**AGENDA**  
CHARTER TOWNSHIP OF MERIDIAN  
ZONING BOARD OF APPEALS MEETING  
June 23, 2021 6:30 pm

**A. ZBA CASE NO. 21-06-23-1 (EROP, LLC), 2390 E. Federal Drive, Decatur, IL, 62526**

The variances requested is to construct a drive through car wash facility at 2703 Grand River Avenue.

**To:** Zoning Board of Appeals  
**From:** Keith Chapman, Assistant Planner  
**Date:** June 18, 2021  
**Re:** ZBA Case No. 21-06-23-1 (EROP, LLC)

DRAWING: **C-2**

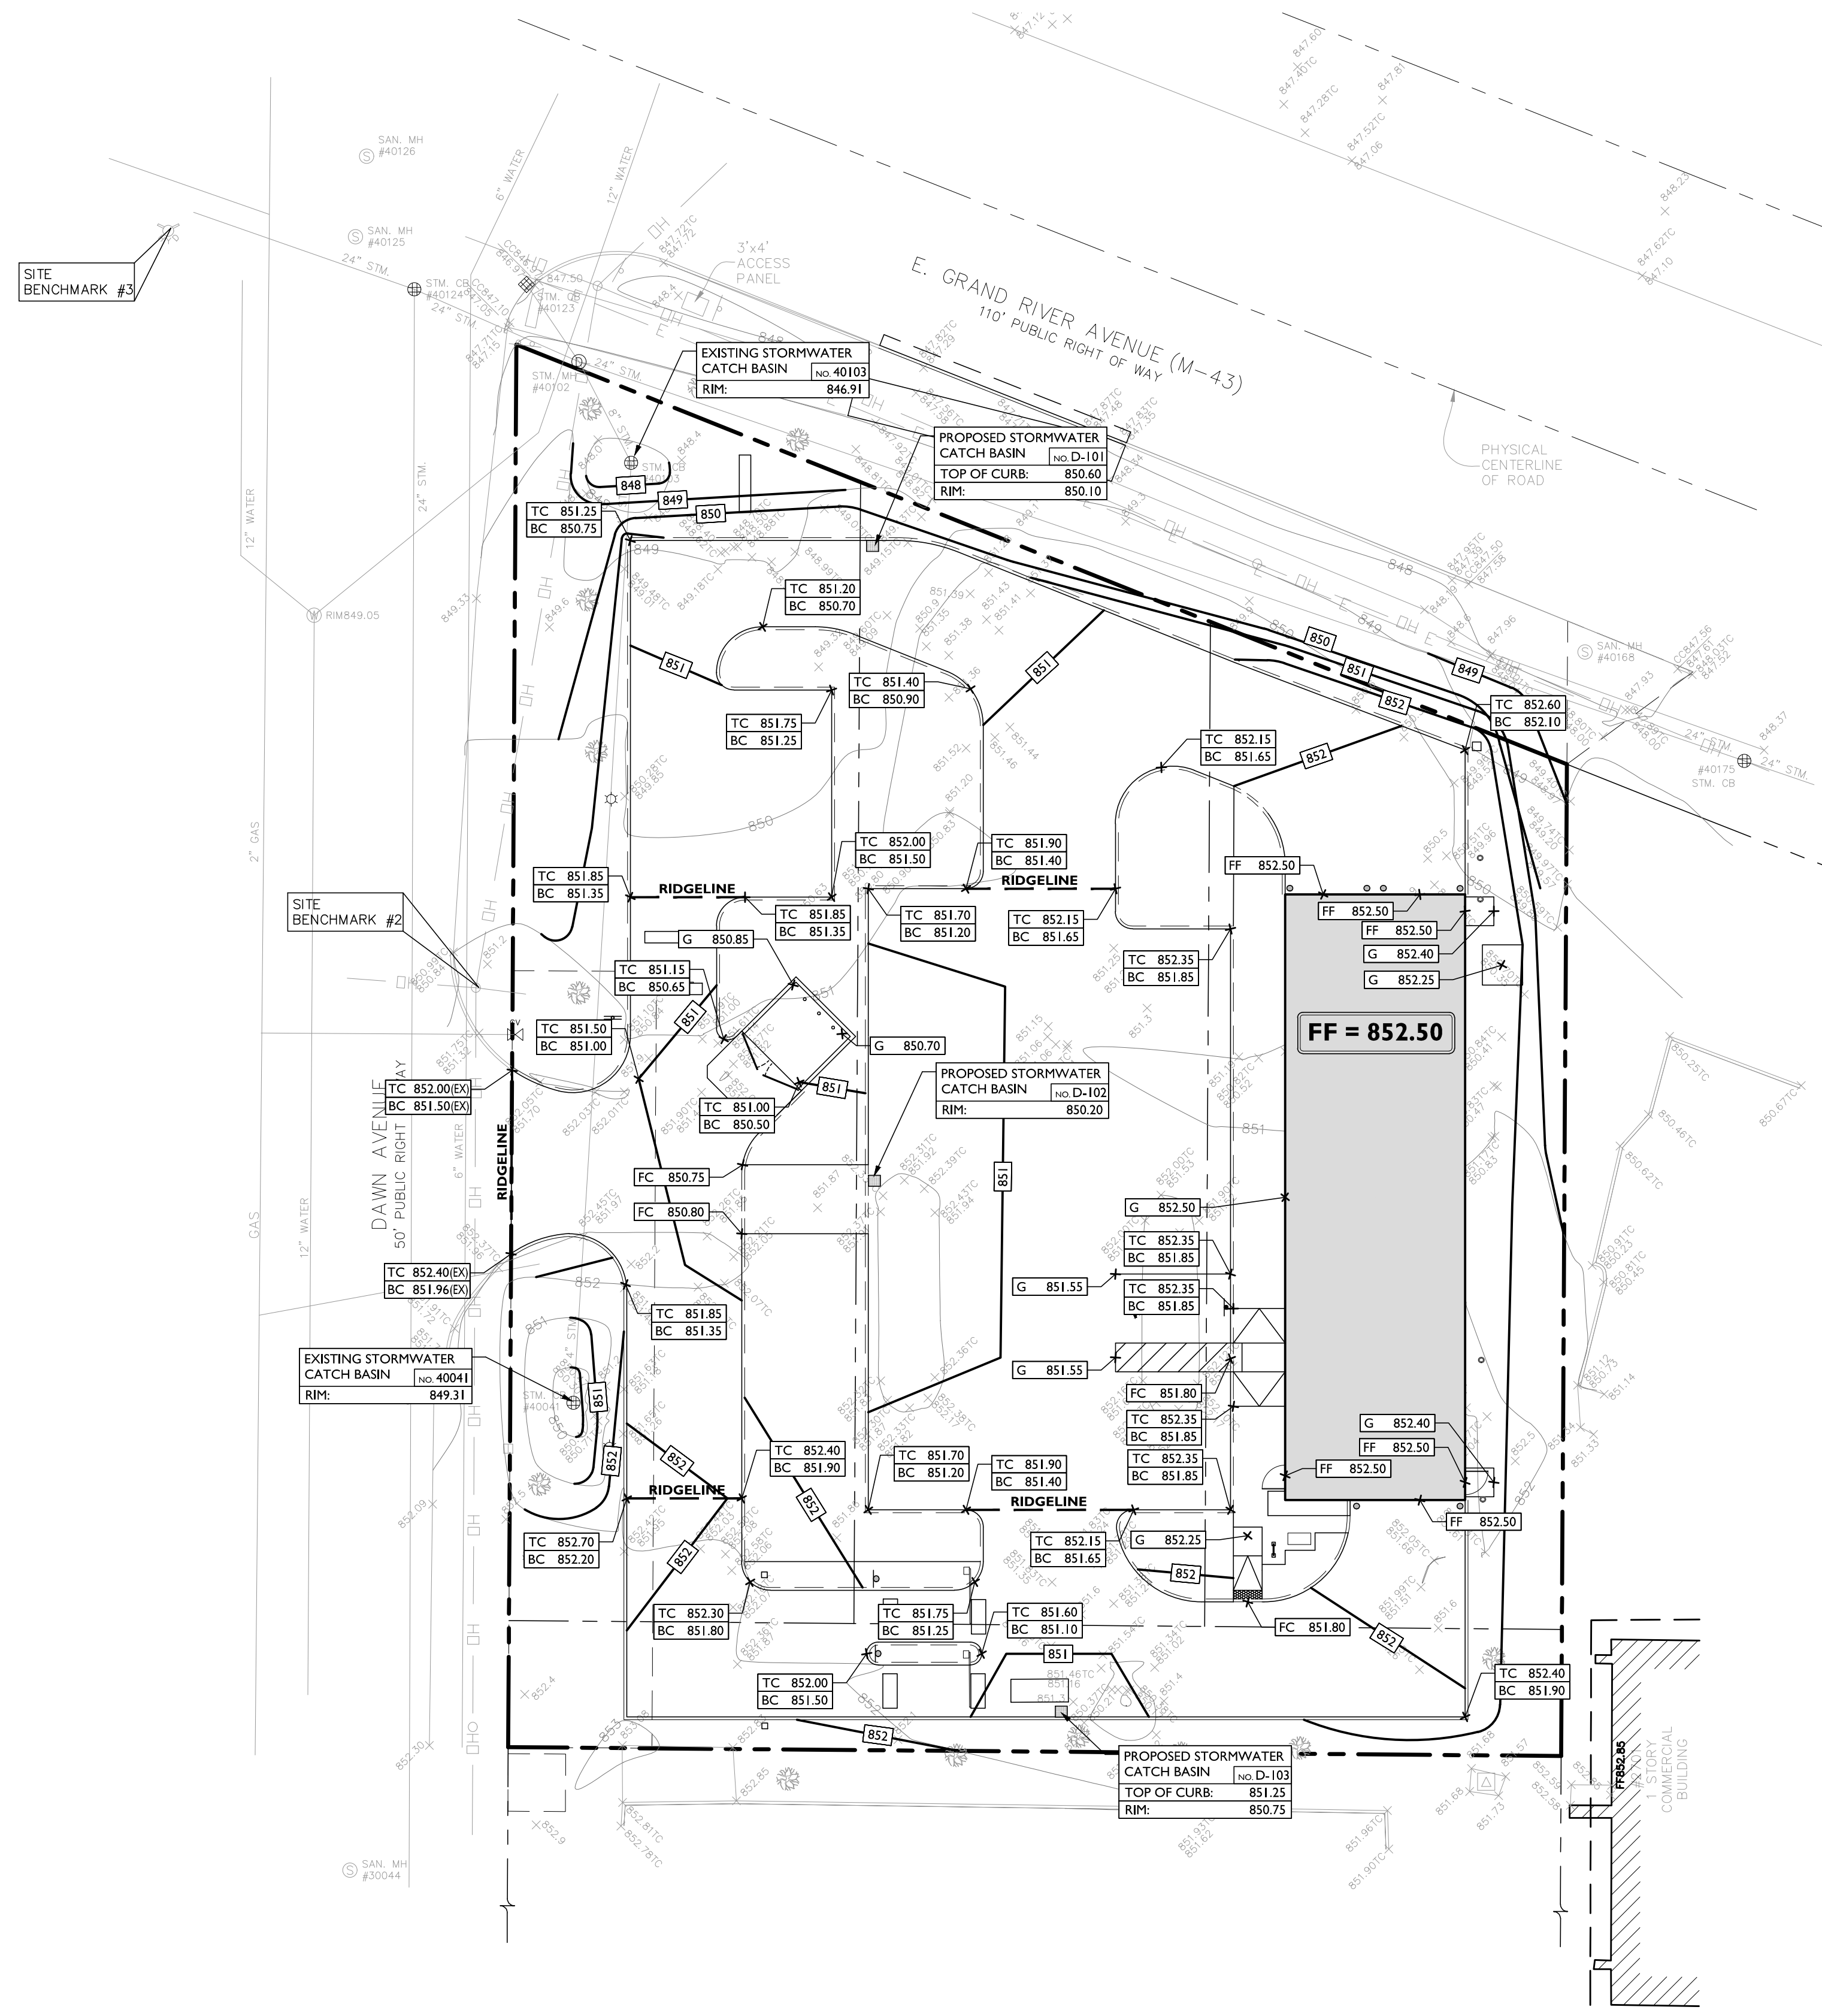
The submitted site plan shows the existing building has an 80.8 foot front yard setback from the centerline of Grand river Avenue right-of-way. Section 86-402(1)(a) of the Zoning Ordinance requires 100 feet from the centerline of Grand River Avenue right-of-way for principal arterial streets. The proposed building will be located approximately 27.5 feet from the from street right-of-way line of Grand River Avenue.

The parking lot landscape buffer along Grand River Avenue is shown at 3.8 feet. A 20 foot parking lot landscape buffer is required by Section 86-756(11) of the Zoning Ordinance. This is measured from the back of the curb of the parking lot to the street right-of-way line. The landscape buffer is required to contain a vertical screen, consisting of a masonry wall, plant material, a landscaped earth berm, or a combination thereof, no less than three feet in height, to screen the parking area from view along the entire length of this buffer strip.

Section 86-758(2) of the Zoning Ordinance requires a four foot landscape buffer to be located between the west side of the building and the parking lot. Inside of this landscape buffer a minimum of 50% of this landscaped area must be planted with grass, ground cover, shrubs, or other living vegetation. The submitted plan shows a 0 foot landscape buffer between the building and the parking lot.

DRAWING:  
**C-7**

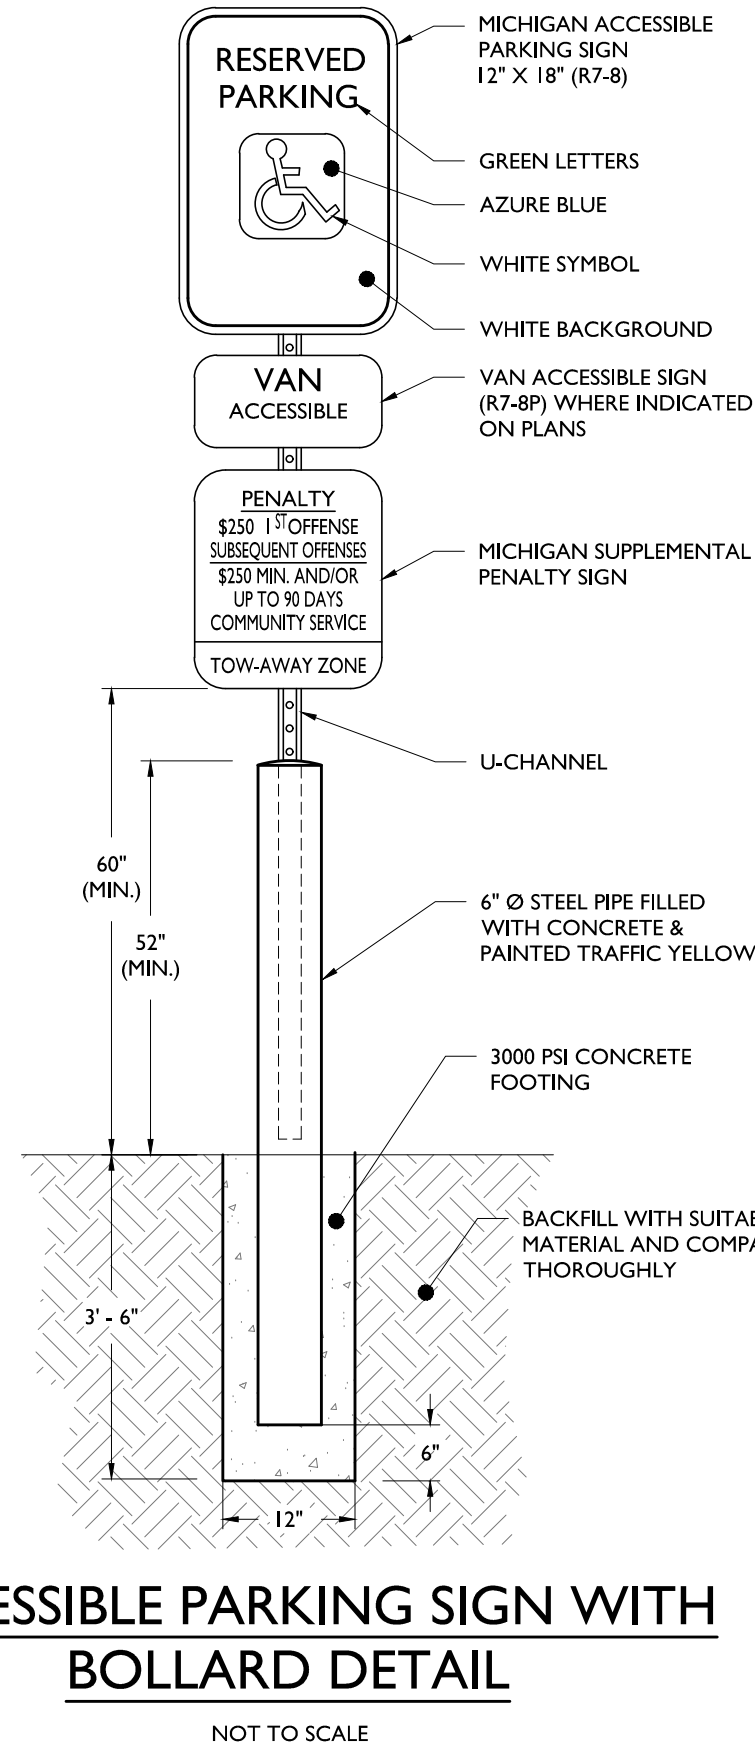
- Building Perimeter Landscaping: Required – 4 ft planting area between parking and building wall, Proposed – 0 ft
    1. *Unique circumstances exist that are peculiar to the land or structure that are not applicable to other land or structures in the same zoning district.*

**Building foundation for the use is not condusive to plantings near the footings**
    2. *These special circumstances are not self-created.*  
**The use requires plantings to be away from the foundation – plantings to be added throughout site**

**The building foundation and safety with the vaccums would be impacted without the variance being granted, additional plantings will be added throughout the site.-**

\* ADDITIONAL PLANTINGS ADDED TO THE SITE LANDSCAPE AREA FOR LOSS OF FOUNDATION PLANTINGS DUE TO FOUNDATION CONCERNS WITH PLANTINGS AS REQUIRED
